The visual amenity of the ETL relocation is discussed in Appendix B3 of the EA, and **Section 4.1** of this Response to Submissions provides and further visual impact assessment work has been completed as part of this Response to Submissions. This work included photomontages, radial analyses and photographs. Refer to previous responses to submissions in this section of the Response to Submissions report.

PART B – MINE PLAN MODIFICATIONS

5.0 Response to Agency Submissions

FIGURE 4.8

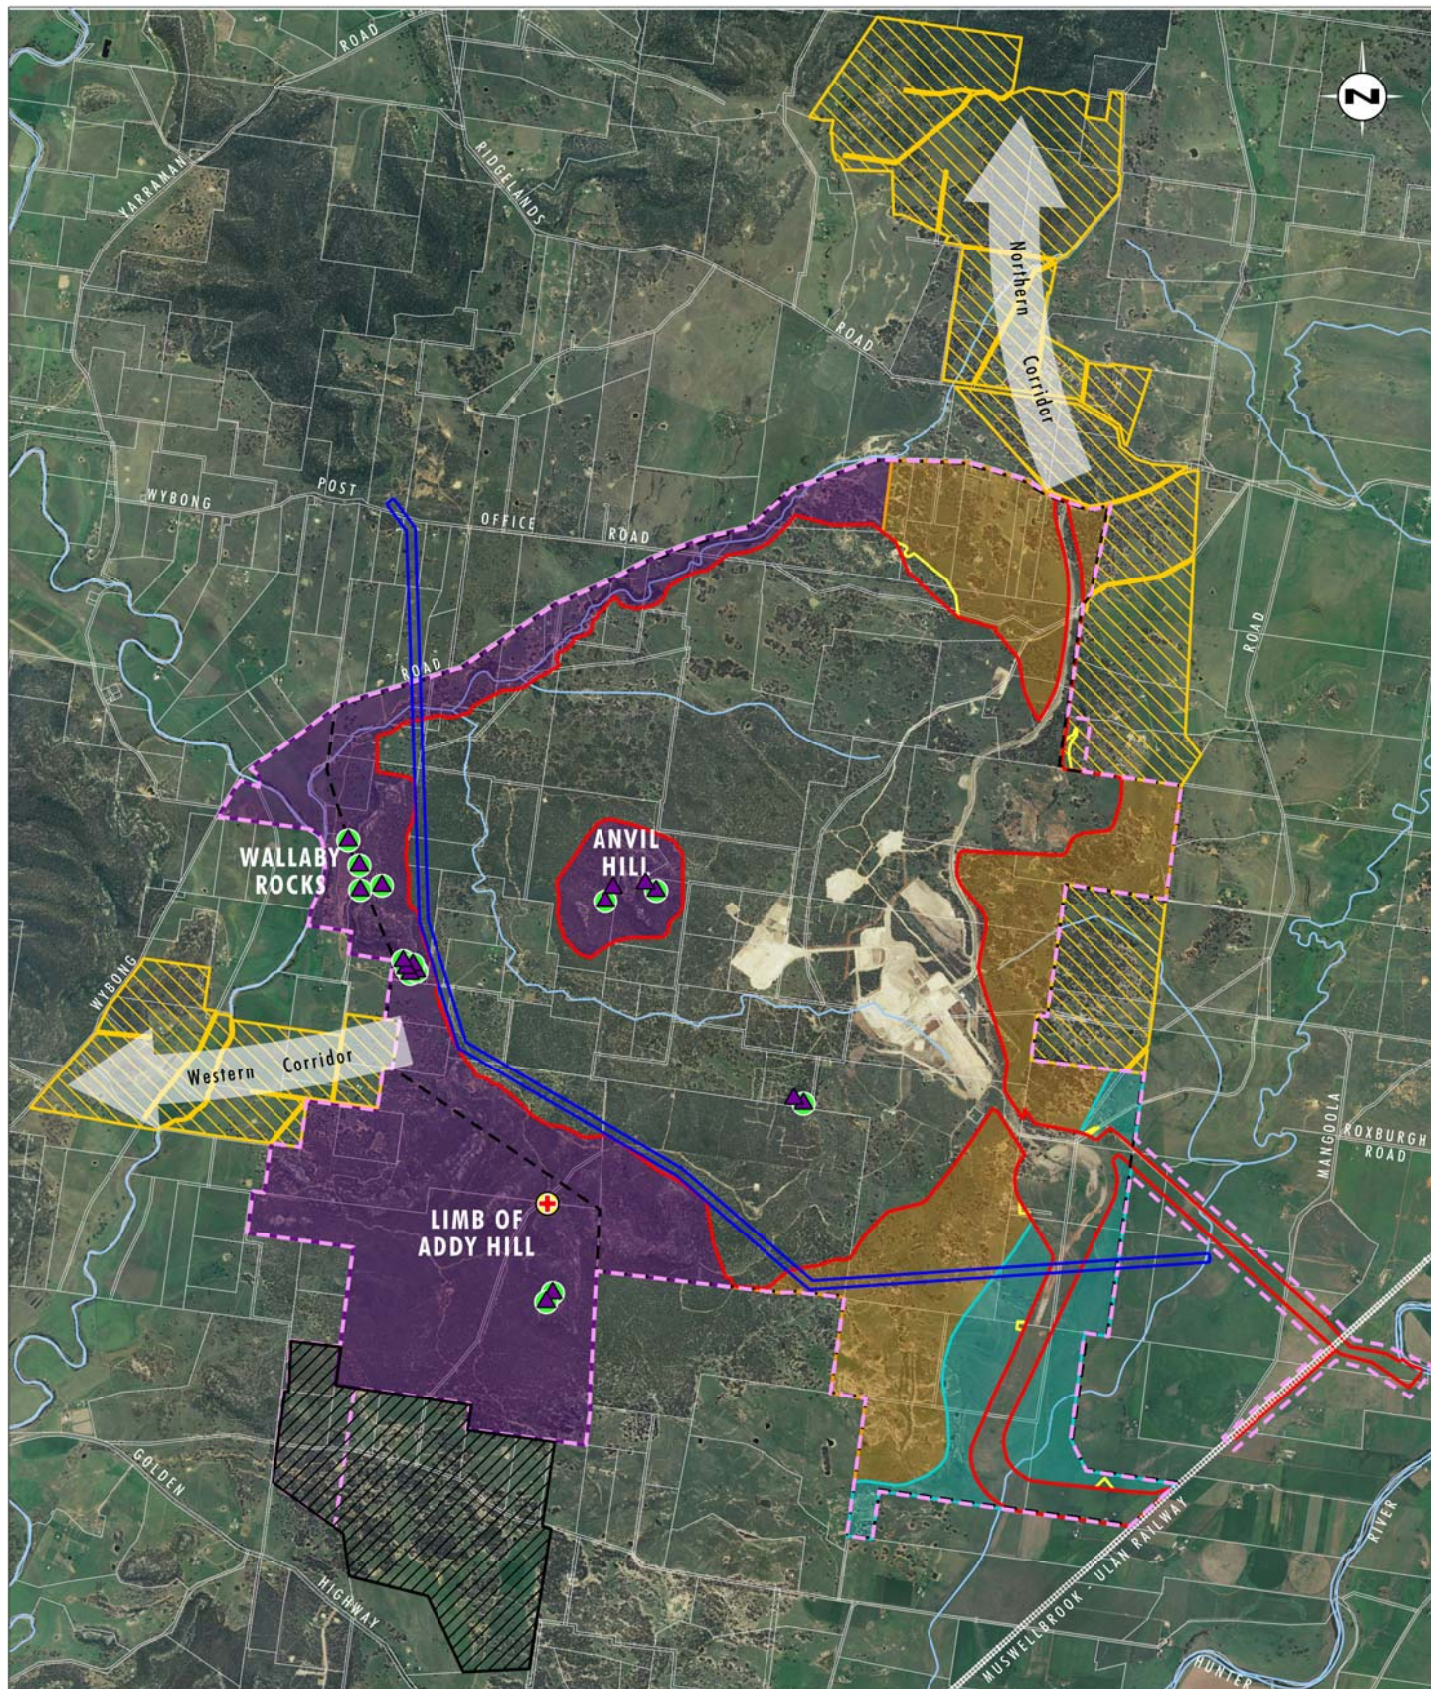
The relocation of the ETL will also destroy the largest known population of *Pomaderris Queenslandica* which is scheduled Endangered under the Threatened Species and Conservations Act NSW. Again the EA has missed this relevant information. This population is inside the existing area of disturbance and will disappear with the current mine plan approval, but we seek the Minister take this opportunity modify the mine disturbance area to protect the *Pomaderris Queenslandica* population.

Figure 4.8 illustrates the location of recorded findings of the *Commersonia rosea*.

Figure 4.8 illustrates the location of recorded findings of the *Pomaderris queenslandica*.

FIGURE 6.1

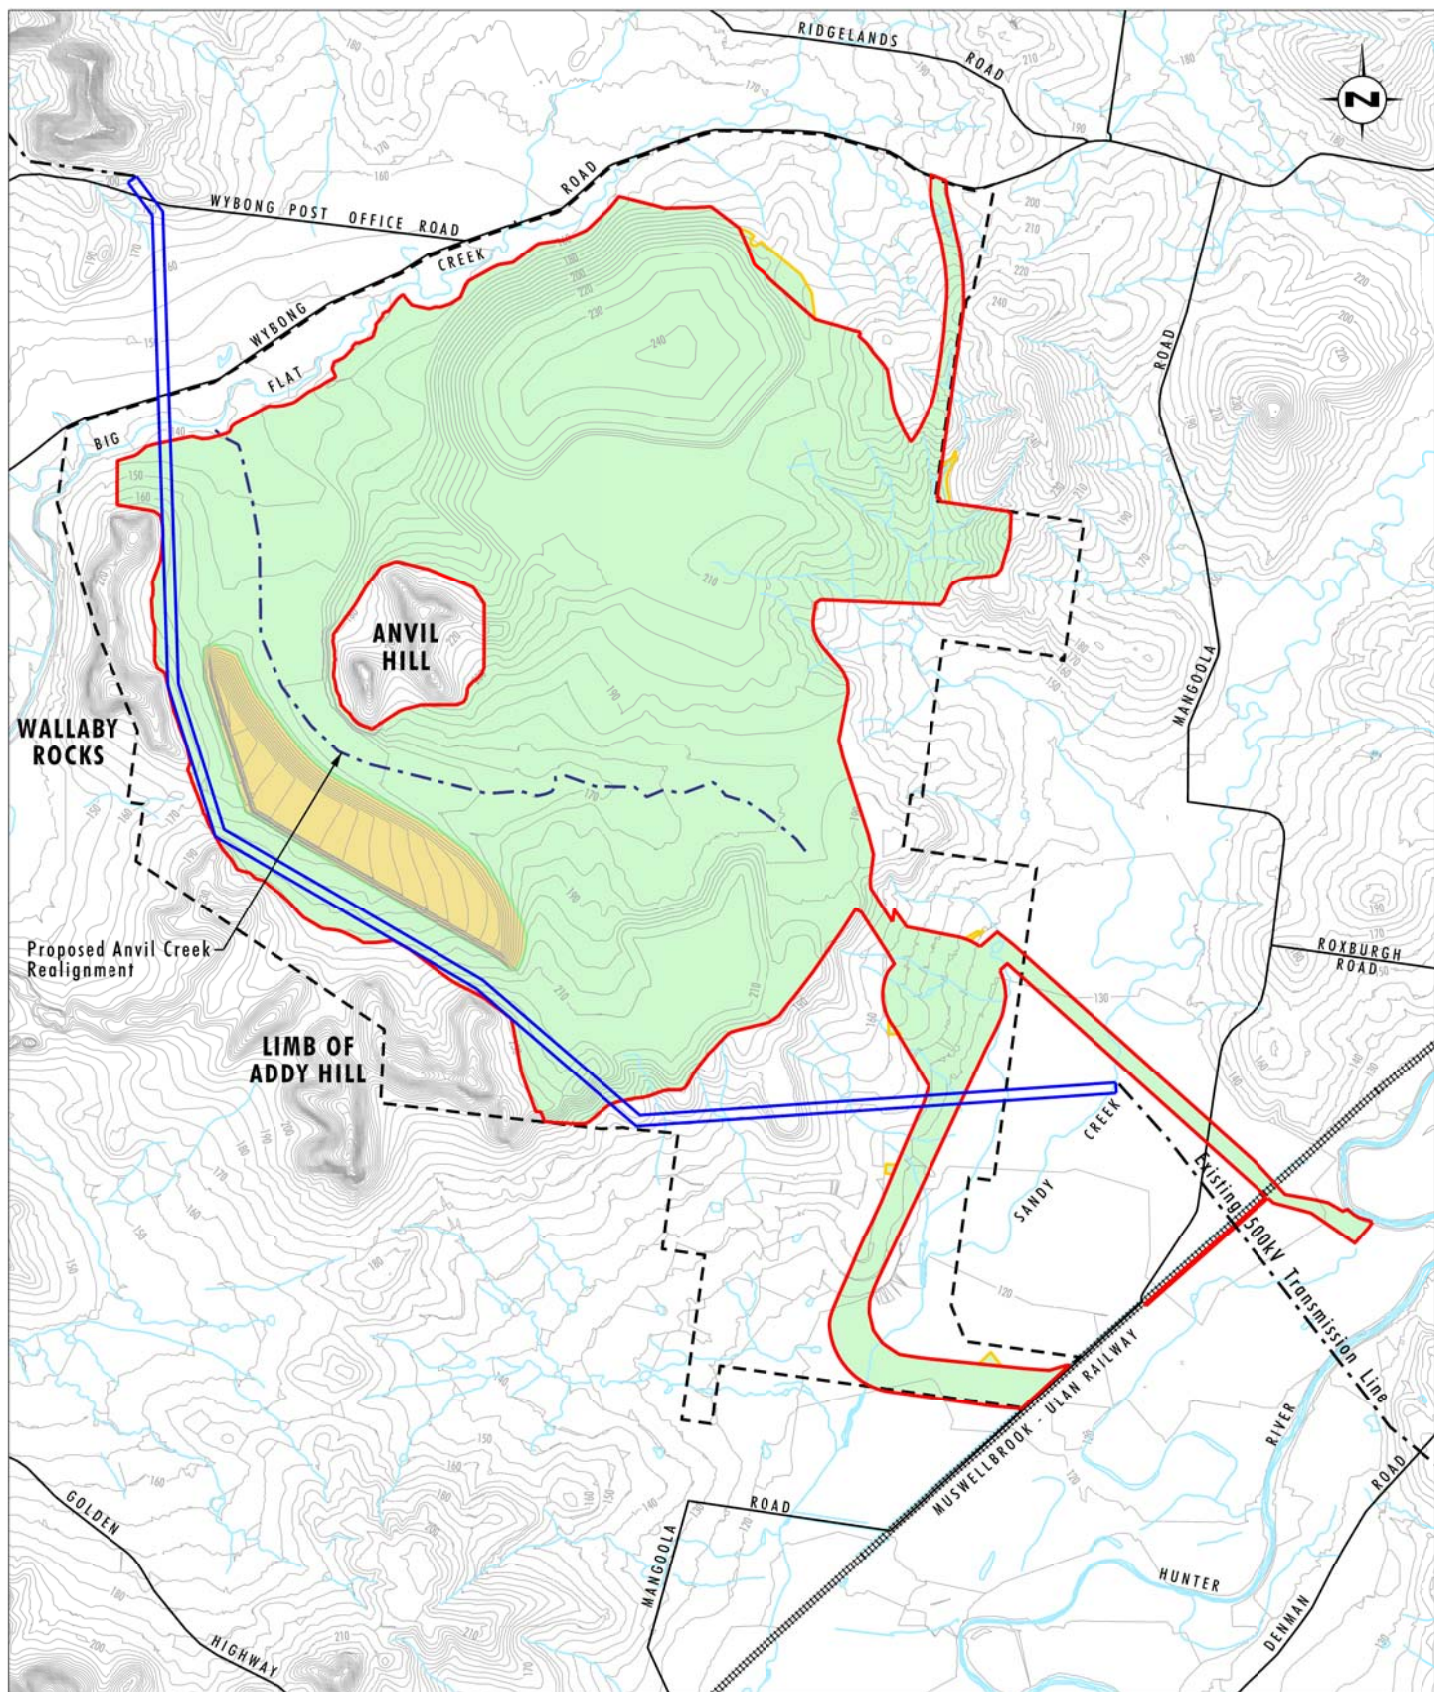
“The changes to the mine plan also result in significantly higher landforms than previously assessed in the northern end of the pit. The approved Project has a maximum rehabilitated height of around RL210 whereas the proposed Project has a proposed final rehabilitated height of RL 240. The most significant difference to the surrounding topography is the unbroken line and volume of the new emplacement combined with the steep sided appearance over a distance of approximately 2400m. The extra height of the embankment will emphasise the volume and scale of the element. “The increase in height of the emplacement will however correspondingly increase the long term visual impacts due to the final bulk and scale of the emplacement. The final emplacement will also be more prominent due to the increase in bench height to RL240. The short and long-term views of Anvil Hill will not be possible due to the extra height of the main emplacement at RL240. The heightened main emplacement will screen the later years of mine extraction to viewers adjacent to VP11.”

Whilst the final landform of the project area will contain landforms at a greater elevation than previously proposed, the conceptual final landform for the proposed modification (refer **Figure 6.1**) has been designed to maintain consistency with the local area and will predominantly consist of an undulating landform reflecting the dominant features of the existing environment. Although the emplacement area will limit views from some properties close to the site in the north, it will also act as a physical barrier between some residents and the mine site. The principles that support the conceptual final landform are consistent with the approved project as follows:

FIGURE 7.1

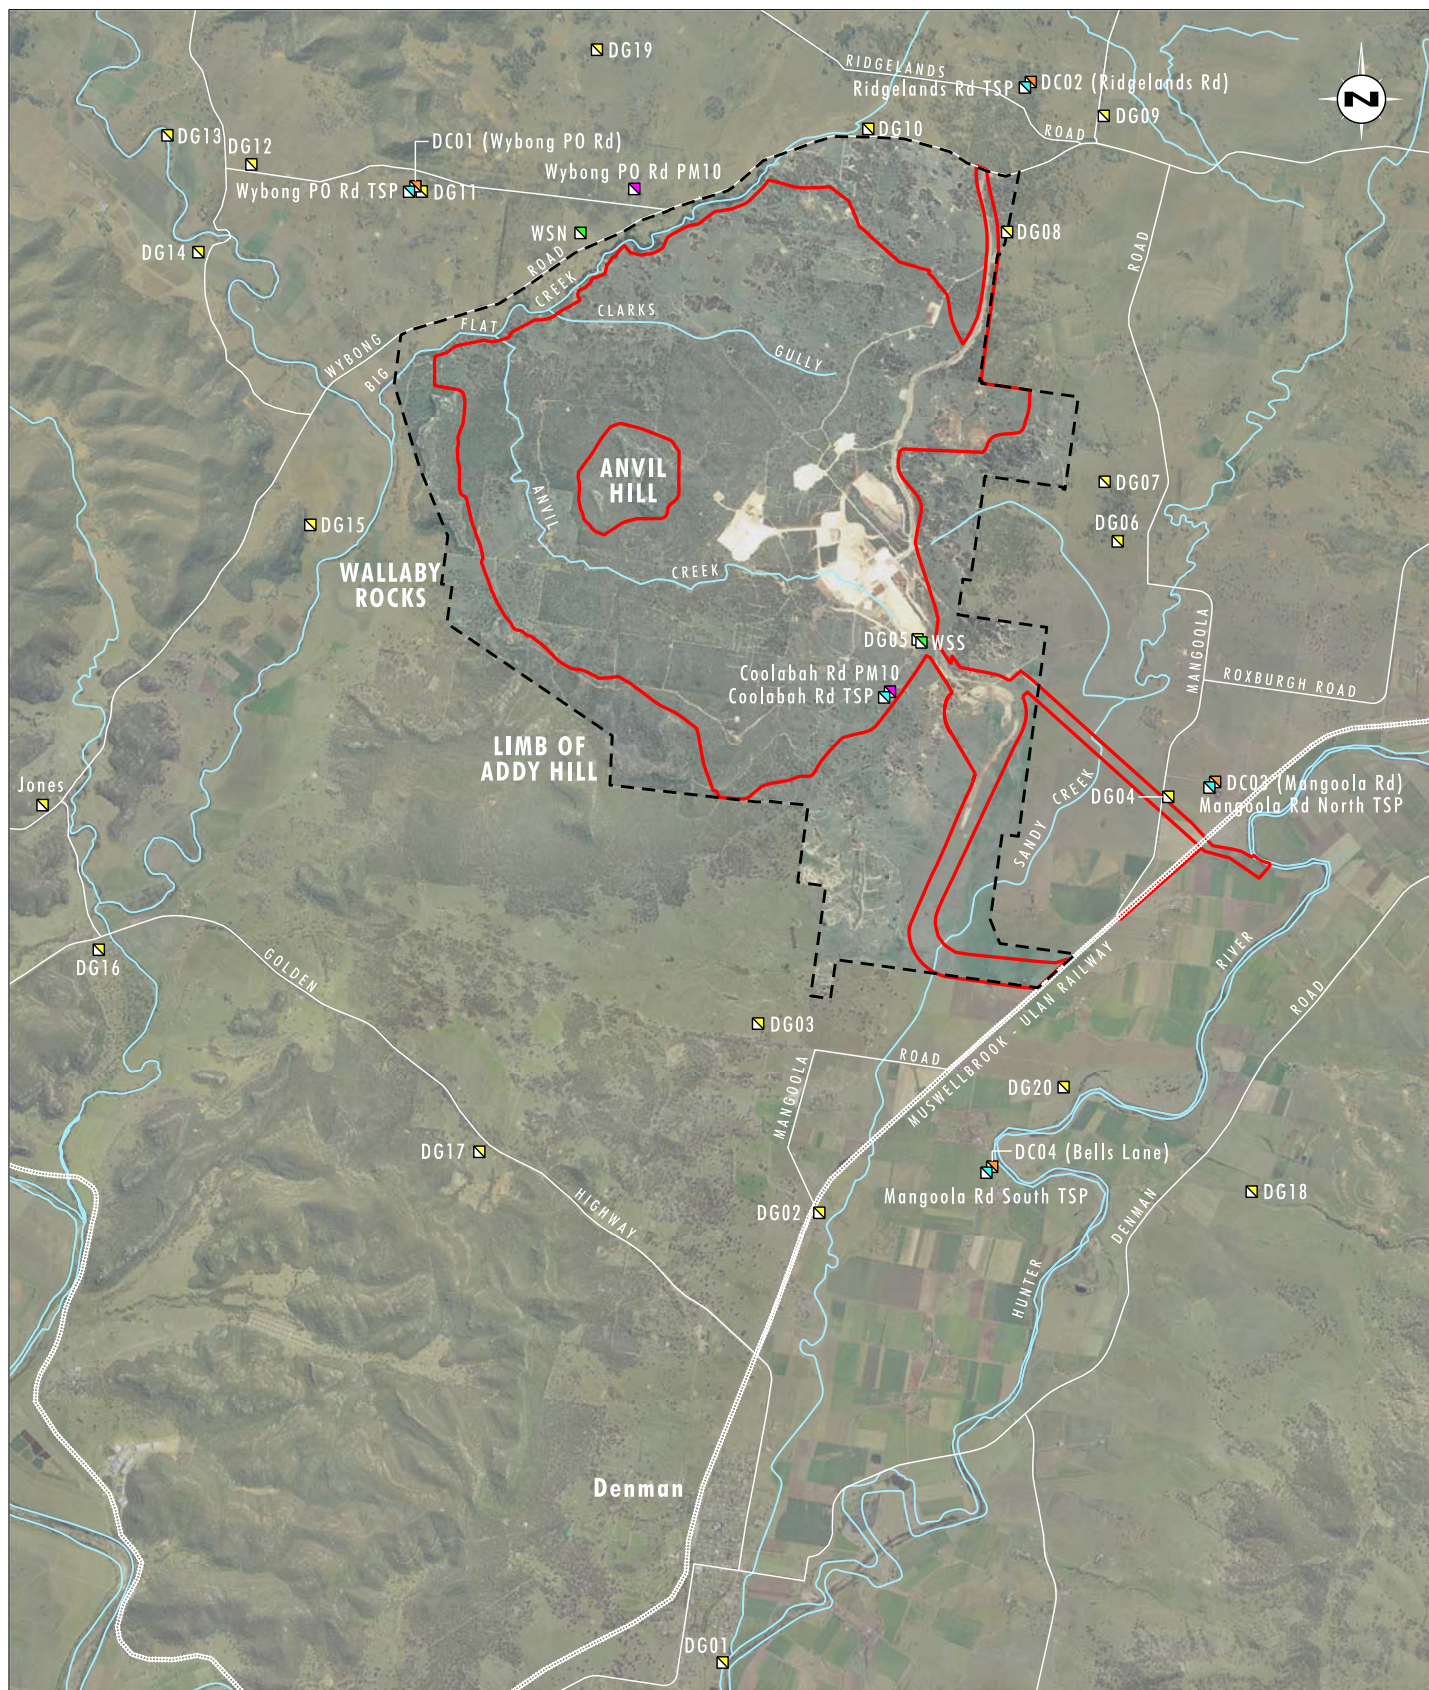
“For maximum 24-hour average PM₁₀ concentrations, the predicted extent of impacts for the modified mine (as defined by the DECCW’s 50 ug/m criterion) are slightly lower than the expected impacts for the approved mine to the south and west of the disturbance boundary. Slight increases are predicted to the north and north-east.”

Many weather events come from the south west into the Castlerock area. The valley landscape creates a tunnelling effect and I question how Mangoola Coal will monitor and manage the increased dust fallout on Castlerock residents beyond the lease area.

The depositional dust monitoring network is illustrated on **Figure 7.1** and consists of:

In addition, four real-time continuous dust monitoring instruments will be situated to the east, north-west, south-east and south of the mine (refer **Figure 7.1**).

Mangoola Coal has installed four real-time monitoring instruments to the north-east, north-west, south-east and south of the site (refer **Figure 7.1**). The locations for the real-time monitoring instruments were selected taking into account the local topography, the nearest residences and the predominant wind directions.

Figure 7.2 - Measured Noise Levels at SentinelX 80 Mangoola Coal Mine

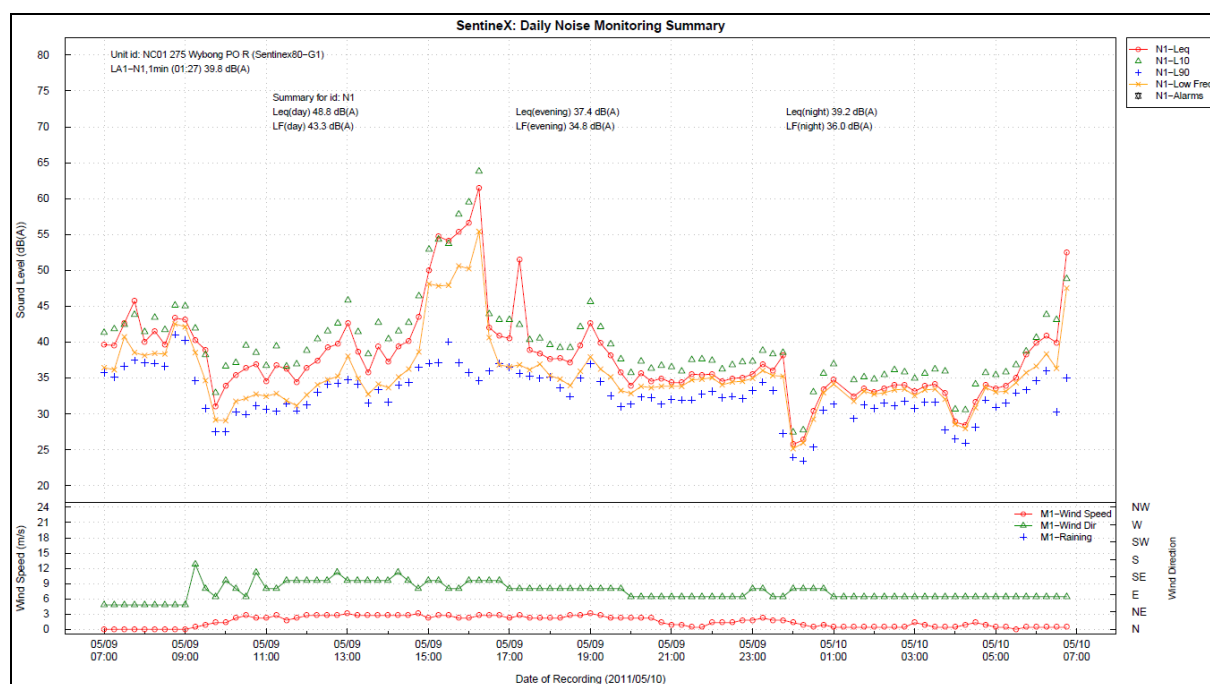
The Noise Impact Assessment uses the DEFRA reference curve to assess low frequency noise. DECCW considers the low frequency modification in the Industrial Noise Policy should be used for the assessment of low frequency noise. DECCW proposes that if any complaints about low frequency noise are received, the proponent should thoroughly investigate these and mitigate any confirmed impacts.

The 24 hour run chart from SentineX 80 illustrating the relationship between the 20 Hz to 630 Hz frequency band LAeq, 15minute noise level and the corresponding LAeq, 15minute noise level is presented in **Figure 7.2** below.
